**PLANNING COMMISSION MEETING
MUNICIPAL CENTER COUNCIL CHAMBERS
Tuesday, September 4, 2018**

3.a. TraVure Planned Development, Phase 4 (Mixed Use Retail/Office Buildings), Request Revised Preliminary and Final Plan Approval

Development Case Number:	15-524
Case Name:	TraVure Planned Development, Phase 4
Location:	Southwest corner of Poplar Ave. & TraVure Drive East
Owner/Developer Name:	Gill Poplar Phase 4, GP

FDC:

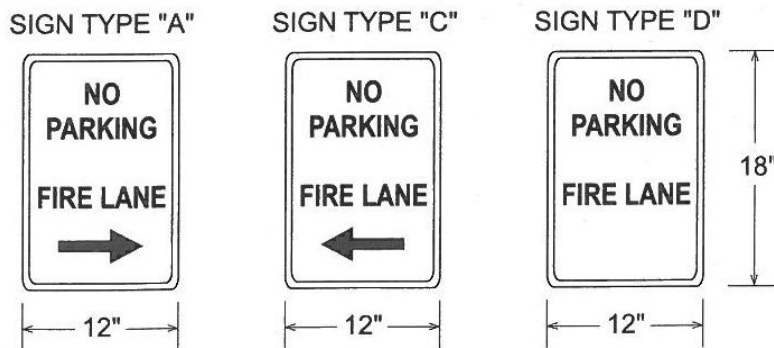
- The fire department connections (FDC) shall consist of two 2 1/2 inch connections using NH internal threaded swivel fittings with 2.5-7.5 NH standard thread.

- The fire department connections (FDC) shall consist of two 2 1/2 inch connections using NH internal threaded swivel fittings with 2.5-7.5 NH standard thread. There shall be a 2 1/2 inch fire department connection for each 250 gpm required for the fire pump. Where more than (2) connections are required to meet the demand of the fire pump, a 5" Storz connection may be used.

PROPOSED REVISED FINAL PLAN
 (Addresses comments from the Smart Code Review Committee)
 Enlarged Copies are included in PC Package

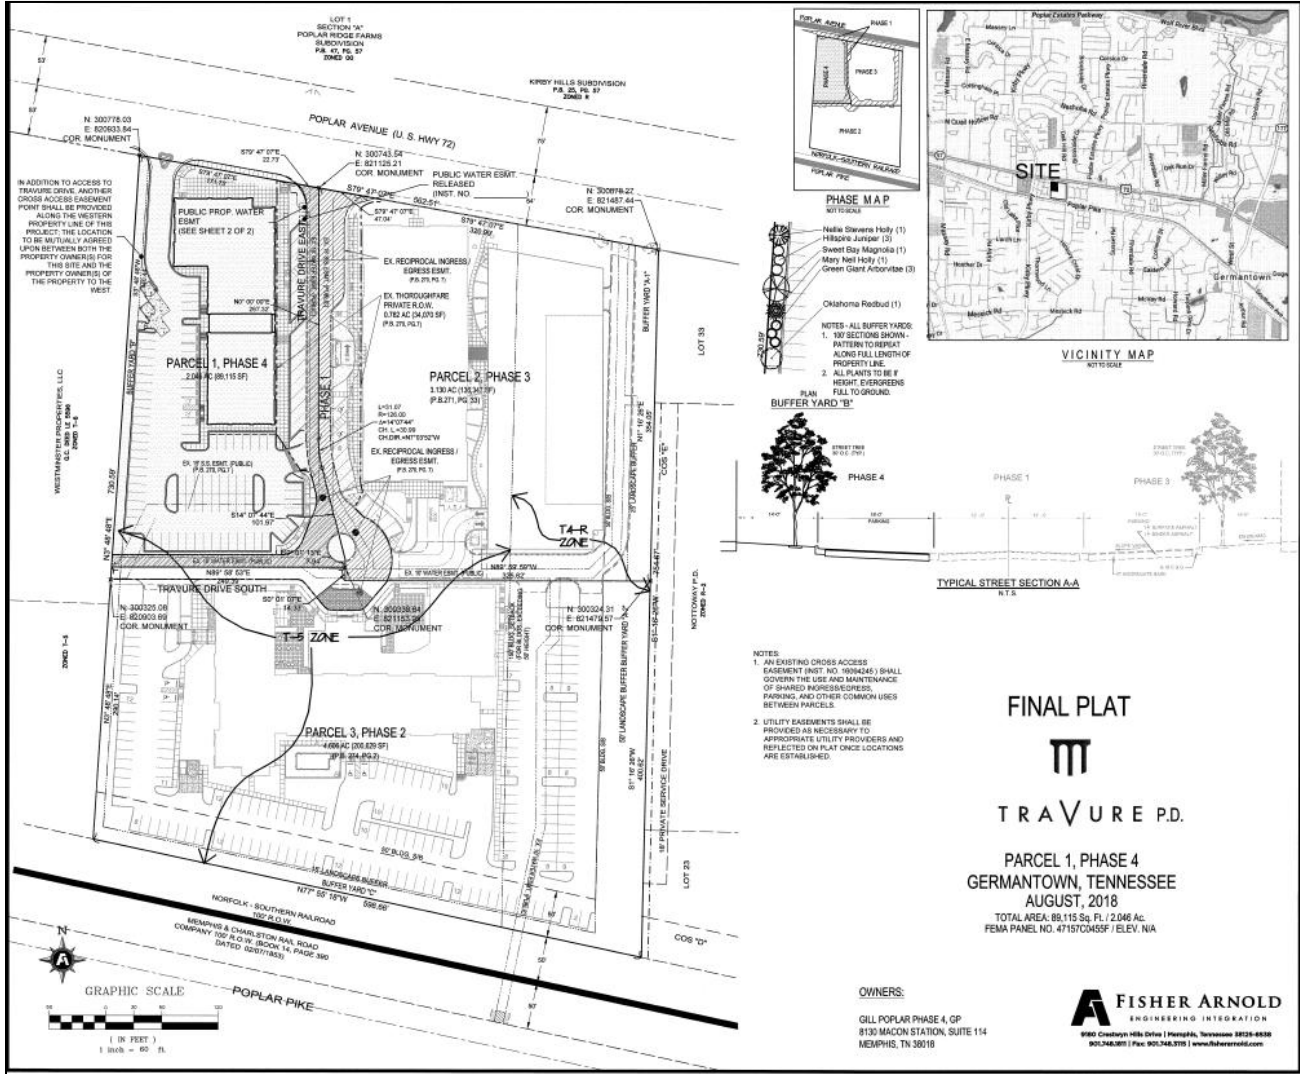
5. *Exterior Lighting:* Detail provided on plans. Photometric plan information is unclear. The plan should reflect foot-candles at the western property line as 0. And the Average lighting levels measured at the building frontage not exceeding 2.0 foot-candles.

- d) Either remove or relocated parking cover located on the western side of the proposed building to allow unobstructed fire access (aerial) via the drive aisle in this area.

- j) Sec. 23-792(c) (2): Parking islands shall be large enough for trees, low shrubs and ground cover. Parking islands shall be a minimum of 180 square feet in area. The plan shows two parking islands. They should be increased in size to meet this requirement or a warrant is required.

- k) Sec. 23-792(c) (4): Pedestrian circulation shall be provided for within parking areas. This information should be reflected on the site plan.
- l) Sec. 23-792(d): A bike rack is shown on the plan. Provide information on the number of bike racks to be provided in this phase in the site data table.

- m) Revise sheet 16 to make information legible.
- n) Foot-candles at the western property line should be 0. Revise accordingly.
- o) Sec. 23-796(b) (4): Average lighting levels measured at the building frontage shall not exceed 2.0 foot-candles. Information unclear on sheet 16. Clarify.

- 1. Move the fire dept connection, PIV, and hydrant to the west side of the drive from the building.
- 2. Check for conflict between the proposed water line location and proposed underground detention area.
- 3. On all plan sheets that show Poplar Avenue, show the revised approved Poplar striping plan.

- WIV and PIV currently show as wall mounted with parking spaces in front of them. FDC and WIV to be relocated to prevent being obstructed by parked vehicles.
- Fire hydrant must be located within 100' of the FDC.
- Must provide 1 fire department aerial access roadway that runs parallel to one side of the building in accordance with IFC (2012) Section D105.3
- Provide a plan sheet with an auto-turn program verifying that aerial apparatus can maneuver through FD access routes.

- 1) The parking canopy in the rear has been re-designed with materials and colors matching the building material. It has also been designed to provide the necessary clearance between the canopy and the main building to avoid the requirement for fire sprinkler treatment.
- 2) The parking canopy re-design has resulted in the reduction of one, standard parking space.
- 3) The crape myrtles proposed in the Poplar frontage patio has been replaced with Bloodgood Japanese Maples.

Previously Proposed Revised Site Plan (As reviewed at Smart Code Review Committee)

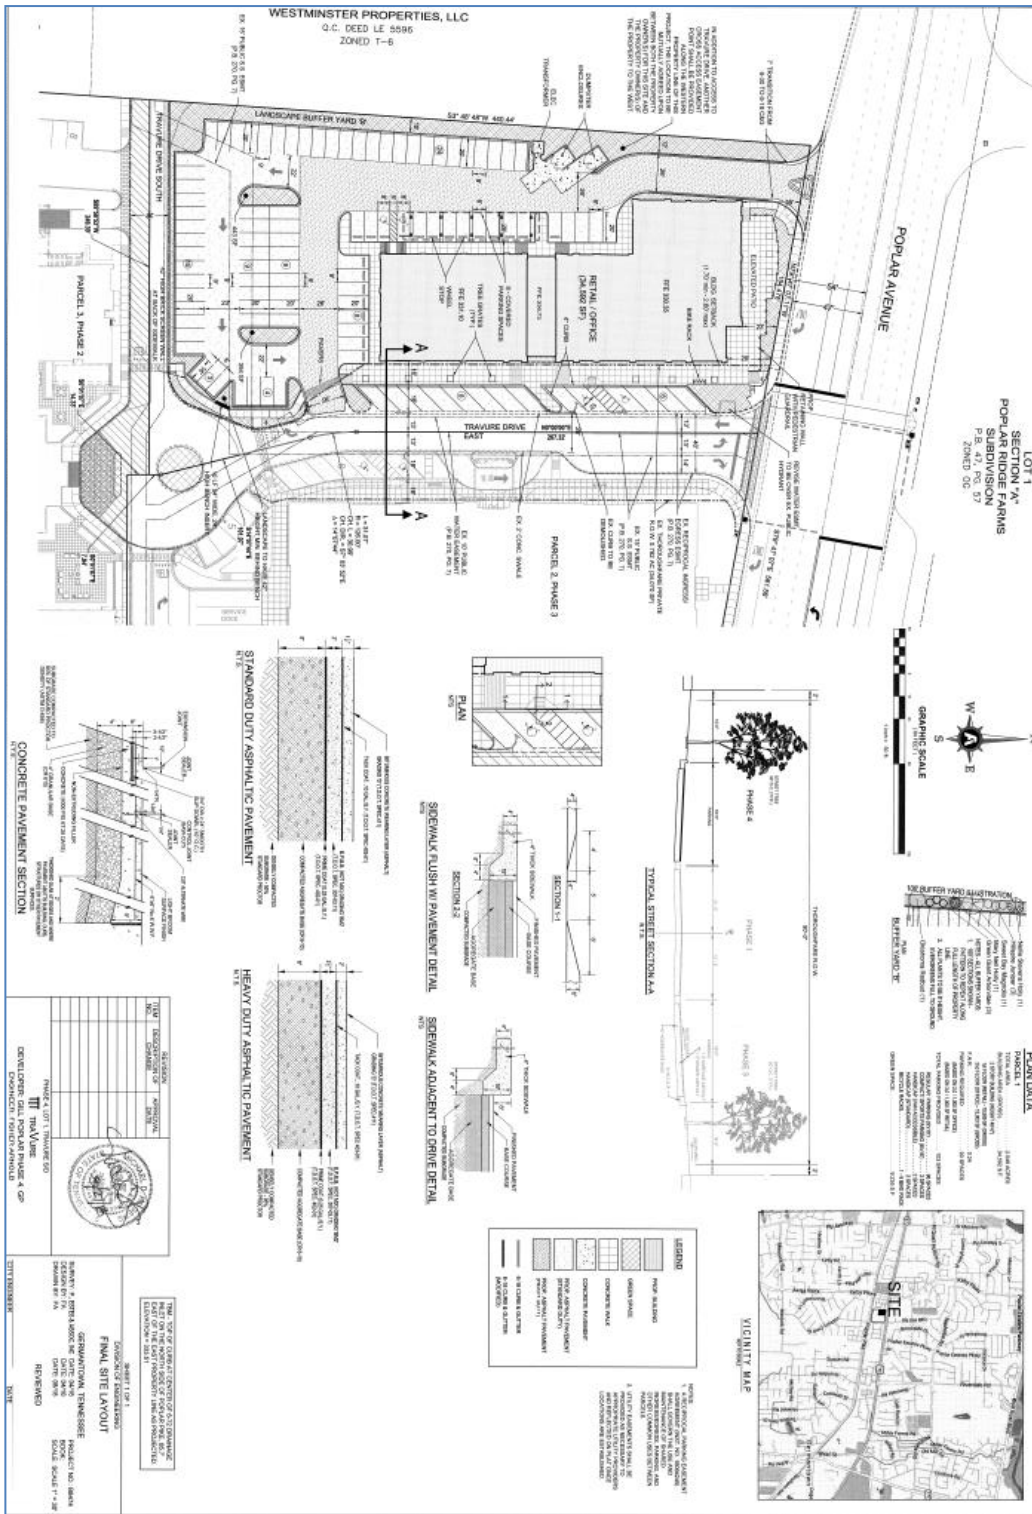
- The design of the covered parking has been modified to have more substantial columns and designed to be a more integrated part of the building, resulting in the loss of one standard parking space.
- The landscaping on the front of the building was modified from crepe myrtles to Bloodgood Japanese maples.
- There are two remaining warrants that are part of this application.

The landscape plan was briefly discussed and a few minor plant changes will be made in the patio area. (Crepe Myrtles to Japanese Maples). Screening the utilities was still undetermined, but will be addressed in the final plan. A canopy on the west side of the building was proposed as a covered parking structure. More drawings and discussion are needed before this feature is finalized.

Building Elevations

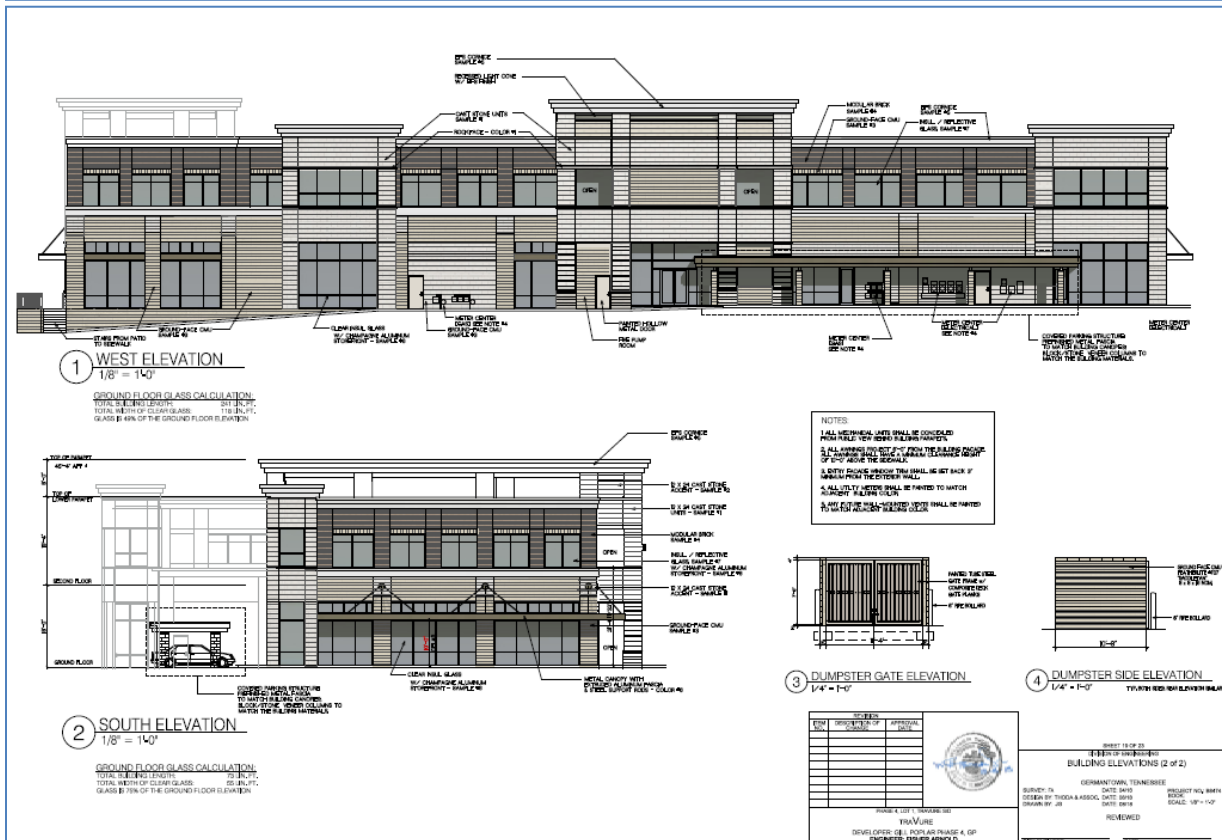
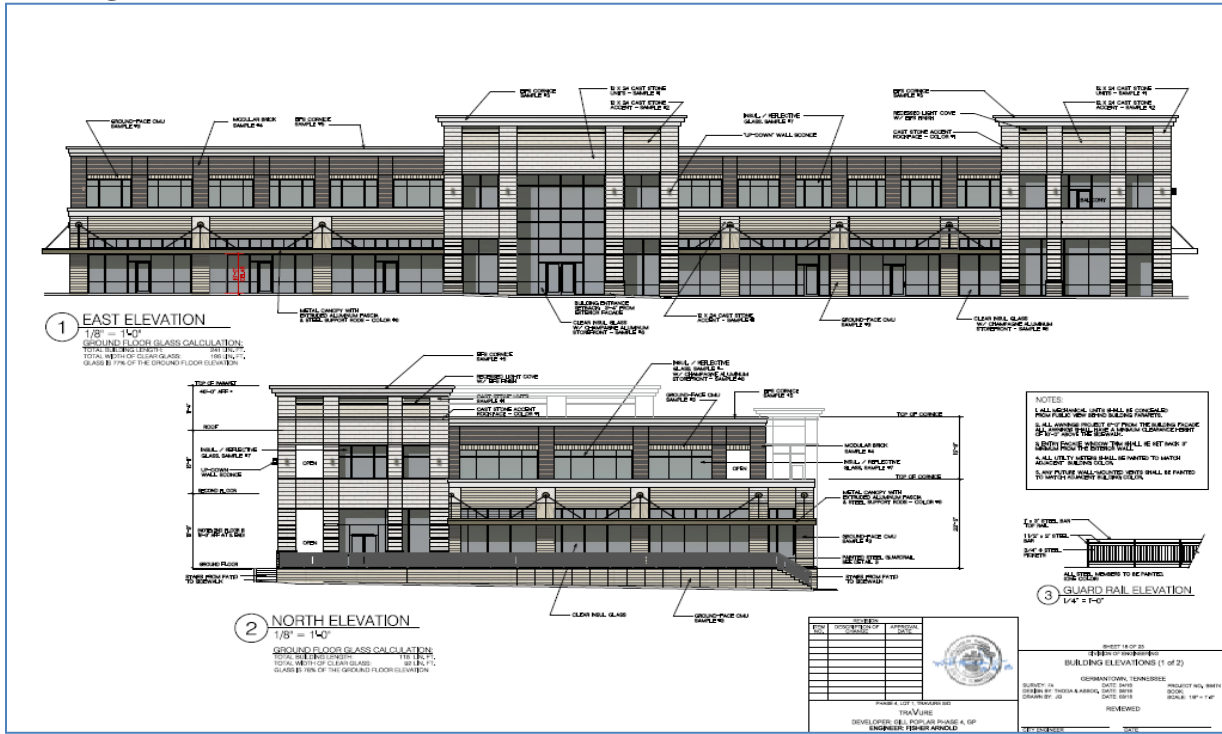
- b) Sec. 23-787(c) (2): Maximum entrance setback: Primary pedestrian entrances on the principal frontage shall be recessed a maximum of seven feet from the exterior façade, and shall remain unlocked during normal business hours. Provide this information on sheet 18 of the building elevation drawings.

- c) Sec. 23-787(c) (3): Canopies and awnings: They shall project a minimum of four feet from the façade, with a maximum projection over a sidewalk to within two feet of a public street curb. The awning or canopy shall have a minimum clearance height of eight feet above the sidewalk. Provide these measurements on the elevation drawings.

- d) Sec. 23-787(e) (2): Entry façade window trim shall not be flush with the exterior wall and shall have a minimum relief of 0.25 inch from the exterior wall. Provide this information on sheet 18 of the building elevation drawings.

- e) Revise the north and west elevations to show the stairs leading to the elevated patio fronting Poplar Avenue.
